I am asking the City Council to once again deny the application for Upper Midhill, LLC (the Applicant) to develop a 34-lot subdivision because there are not adequate public facilities. Specifically, the Applicant does not provide sufficient mitigation to meet all existing demands nor will it satisfy projected demands from projects with existing land use approvals, plus the additional demand created by the application. Further, off-site facilities will remain noncompliant with some applicable standards.

**(2) Restriping Highway 43 to provide a two-way left-turn lane (TWLTL) is insufficient to address increased traffic at an already failing intersection.**

**Figure 22b Typical Two-Way Left Turn Lane Layout at Major Intersections**

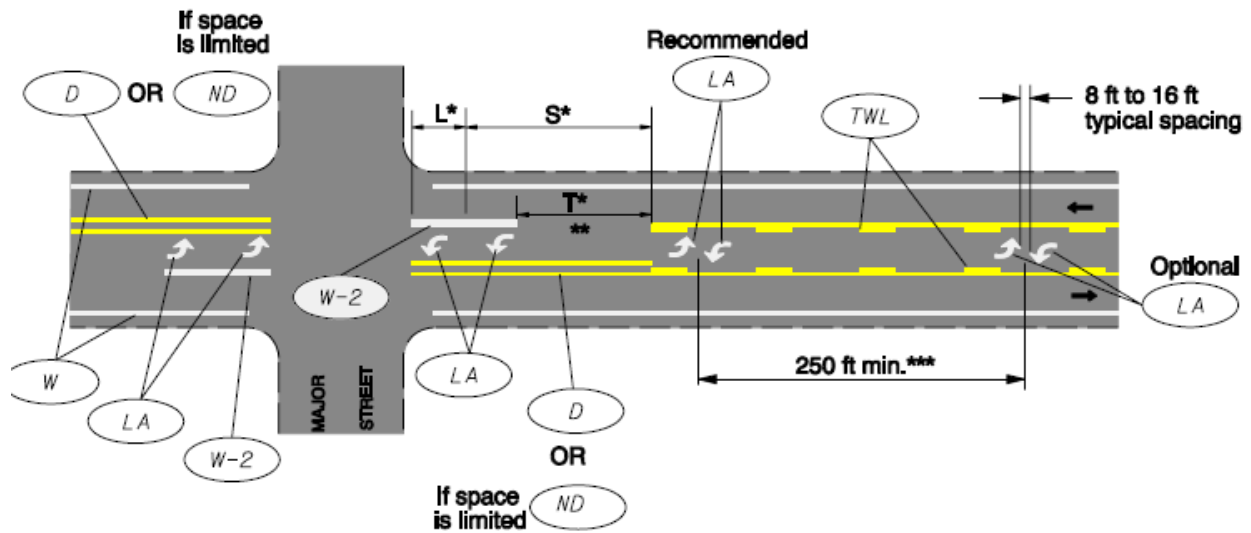
A TWLTL does not come without limitations, especially when applied to a narrow and very busy intersection like Hwy43/Arbor.

“There are some limitations to TWLTLs the designer must keep in mind. **Extra street width may be required, resulting in an increased need for right of way.** In addition, **TWLTLs add another lane pedestrians and bicyclists to cross and do not provide a refuge area for them.** Another limitation is that **TWLTLs may not alleviate safety problems at closely spaced entrances and intersections, where queuing traffic can block left turning movements.**” (Iowa Department of Transportation, page 2)

The proposed mitigation plan does not meet the Oregon Highway Design Manual standards because it does not provide a continuous two-way left-turn lane and “will likely require Design Exceptions” (ODOT 1, page 4; ODOT 2, page 69). The methodology used to design the mitigation assumes that **100%** of motorists will instinctively know how to do a two-stage turn when there is an “acceptable gap” in traffic. “It cannot be overstated that gap acceptance behavior is highly dependent on the driver characteristics and preferences. Therefore, homogeneous behavior from all drivers at all times is not realistic.” (Nabae, Moore, Hurwitz, page 1). Further, there is insufficient data to show that there will be enough “acceptable gaps” for the proposed mitigation to succeed in its purpose during the peak hours of operation. A simple drive through the intersection during peak hours will illustrate that gaps are extremely limited.

How does the proposed mitigation work when there are vehicles waiting in the turn lane and vehicles waiting to enter Highway 43 from Arbor? What happens when there are vehicles waiting on both sides of Arbor and both Highway turning lanes? These types of situations will happen relatively frequently during peak hours and, while they should result in fewer rear-end collisions, they may result in more turning type accidents due to the unusually high volume of traffic at this intersection. The answer from the accepted methodology is that, due to forecasted optimal use of the two-stage turn, these situations won't impact the level of service and capacity.

What happens to the level of service (LOS) and capacity (v/c) of this intersection if fewer than 100% of motorists instinctively know how to use the TWLTL? What happens during peak traffic hours when traffic is backed up for hundreds of feet north of the intersection and there are no acceptable gaps for long periods of time? I assert that a significant number of motorists will prefer to wait for an adequate gap on both sides of travel instead of attempting a two-stage turn.

In addition, the proposed mitigation plans are also unclear as to which ODOT Traffic Line Manual striping standards (ODOT Traffic Line Manual, pages 36-38) will be used. It is logical to assume that different striping plans will impact utilization of the TWLTL. The methodology applied does not allow you to vary the utilization of the TWLTL and is logically flawed or open to different interpretations.
